CERTIFICATE OF APPROPRIATENESS

Property: 516 Columbia Street, Lot 15, Block 286, Houston Heights Subdivision. The property includes a historic 1,536 square foot, one-story wood frame single-family residence situated on a 6,600 square foot (50' x 132') interior lot.

Proposal: Alteration – Construct a rear two-story addition to a one-story contributing residence. The addition will begin from the front façade and will measure wide at the front and expand to wide at the rear and deep. The addition will have an eave height of and a ridge height of.

Recommendation: Partial Approval:

NORTH SIDE ELEVATION

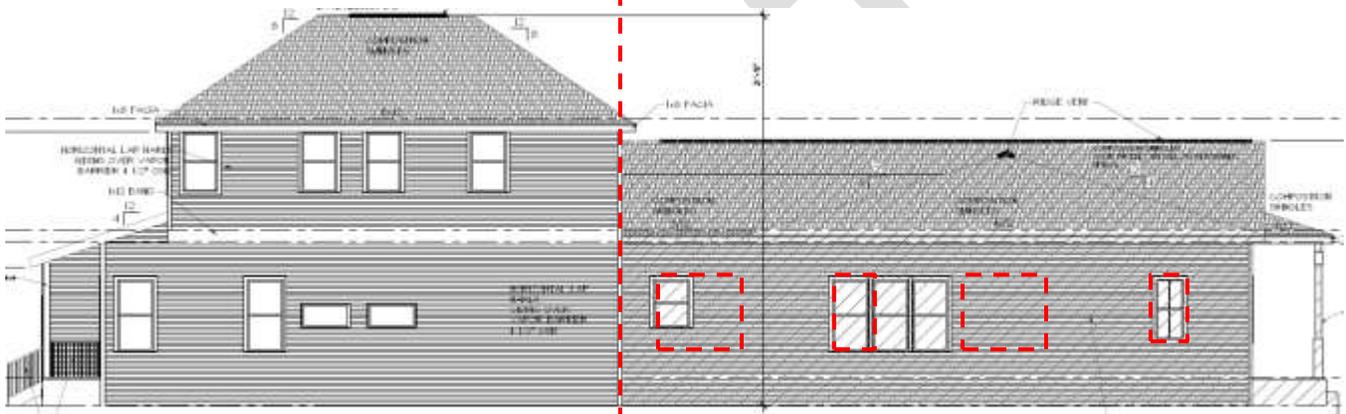
<i>The replacement of the existing 105 and 117 wood siding with cementitious siding, and the replacement of the 1-over-1 and 2-over-2 wood sash windows results in the destruction of significant historic material. The loss of material and alteration to the front and side facades significantly alters the character of the historic contributing structure.</i> | |

Side Elevation: Two existing 2-over-2 will be removed and the openings will be infilled with cementitious lap siding. A 1-over-1 sash window will be removed and a ribbon of three 1-over-1 sash windows will be installed. Two 1-over-1 sash windows will be removed and the openings will be infilled with cementitious laps siding; a new 1-over-1 sash window will be installed.
(North)

Denial of the replacement of the existing wood siding with cementitious horizontal lap siding and the replacement of the existing 1-over-1 and 2-over-2 wood sash windows.

WEST ELEVATION – FRONT FACING COLUMBIA STREET

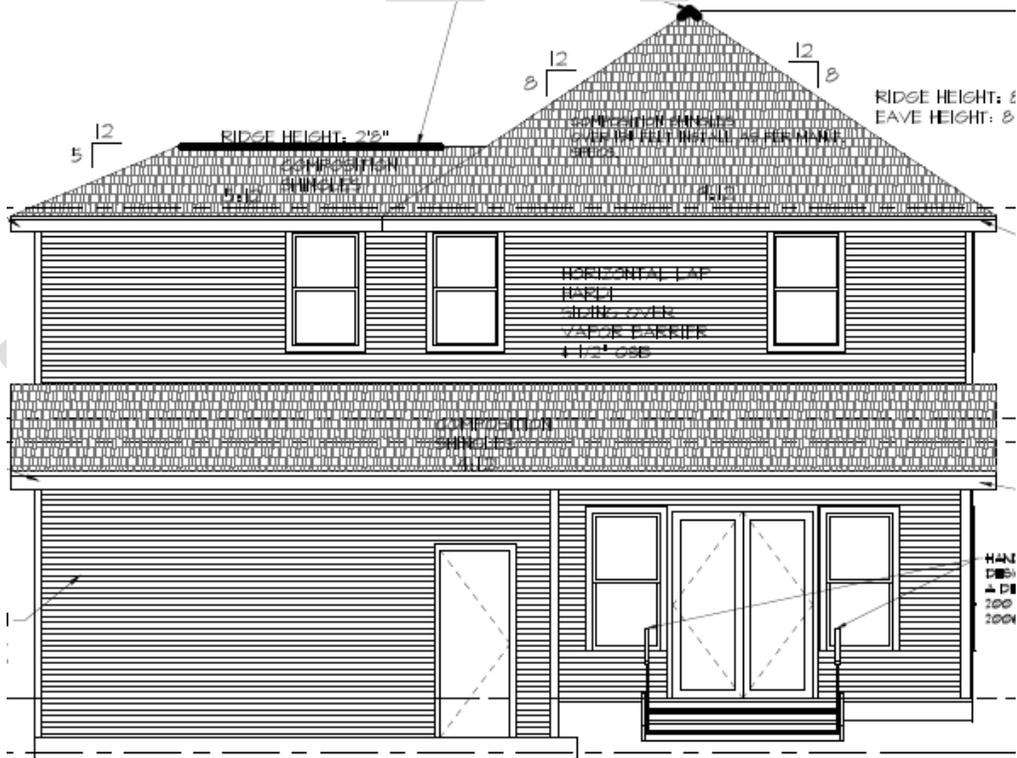
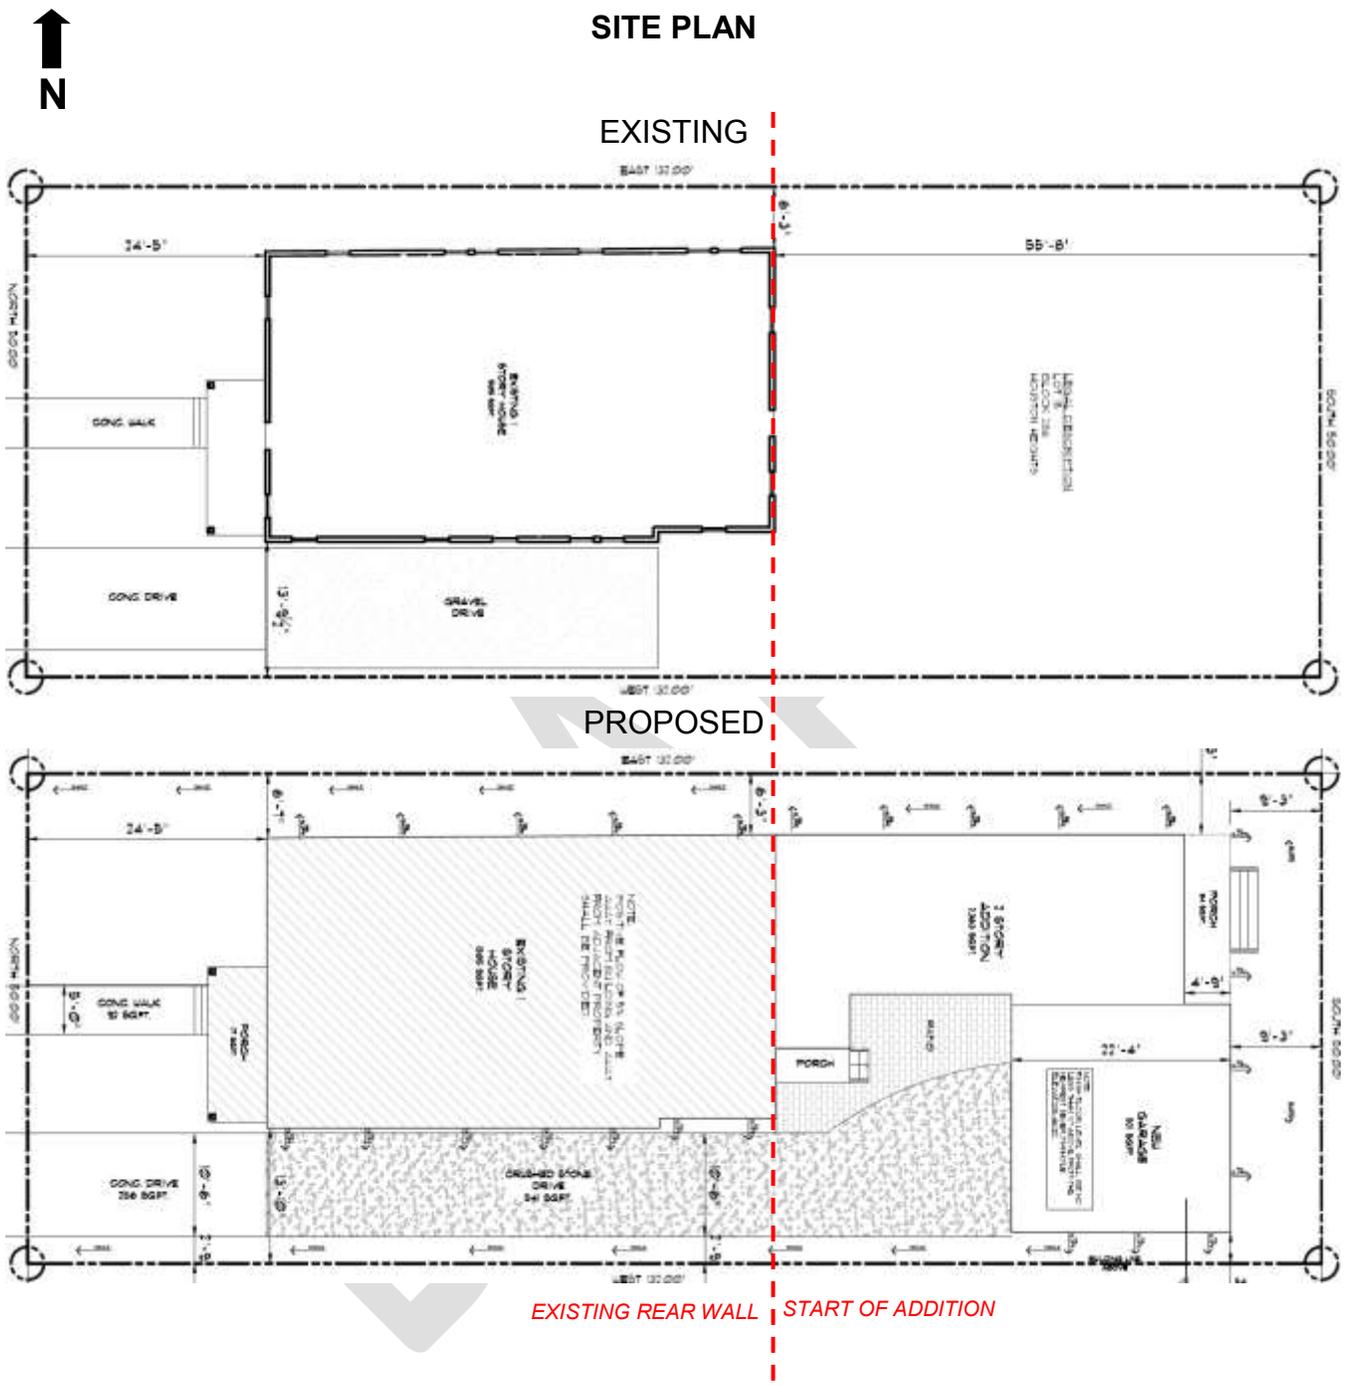
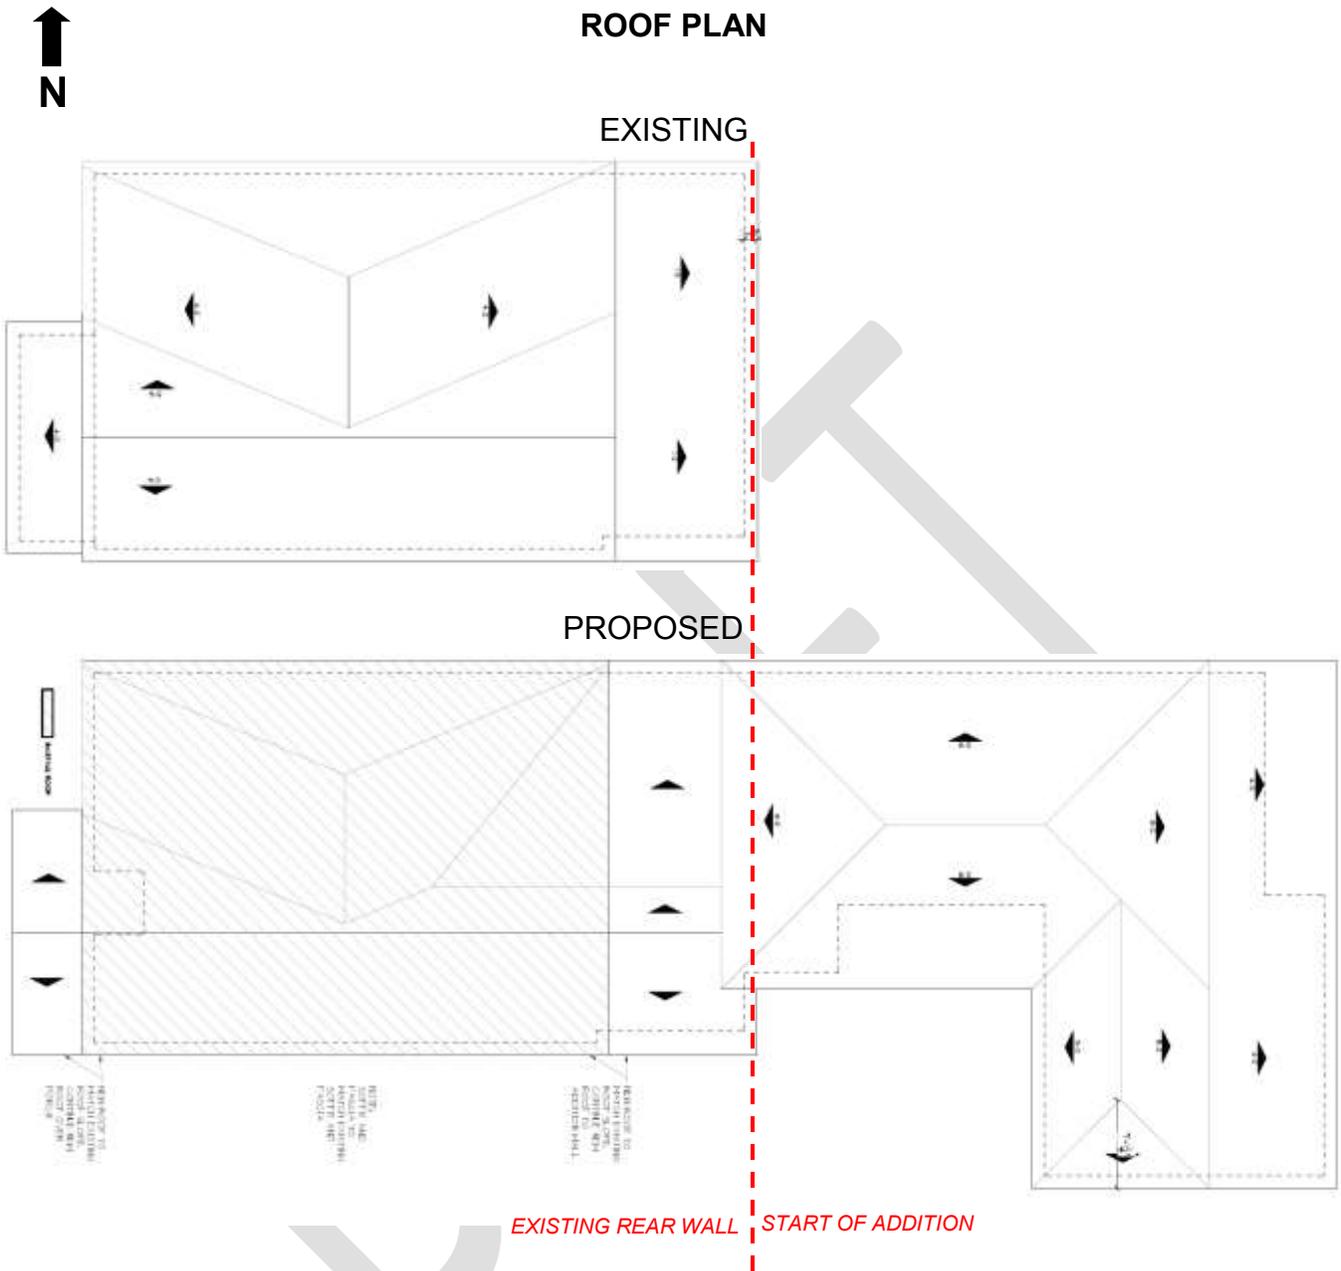
<i>The removal of the existing wood siding and replacement and relocation of the existing 1-over-1 and 2-over-2 wood sash windows results in the loss of historic material and alters the historic character of the contributing residence.</i> | |

Front Elevation: A new 2-over-2 sash window will be installed to the north of an existing 2-over-2 sash.
(West)
